主旨: [FI] S.16 Application No. A/YL-KTN/1136 - FI to address departmental comments

Proposed Temporary Warehouse (Excluding Dangerous Goods Godown) with Ancillary Facilities and Associated Filling of Land for a Period of 3 Years in "Agriculture" Zone,

Various Lots in D.D. 107 and Adjoining Government Land, Fung Kat Heung, Yuen Long, N.T.

(S.16 Planning Application No. A/YL-KTN/1136)

Photo 1 showing Ex. MH A1

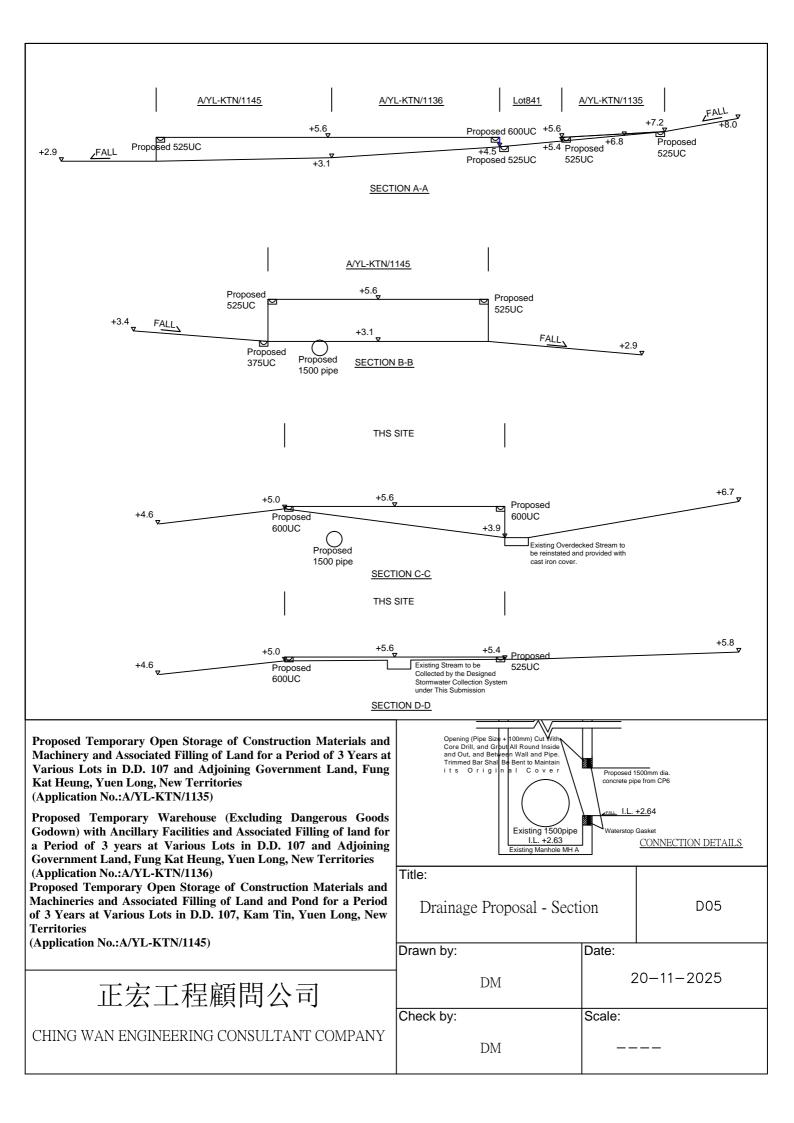
- 5. Since there is no record of the said discharge path, the applicant should provide site photos of existing drainage facilities including the discharge point (e.g. existing local village drain mentioned in the proposal and its downstream drainage facilities) in order to demonstrate the presence and reflect condition of the existing drainage system.
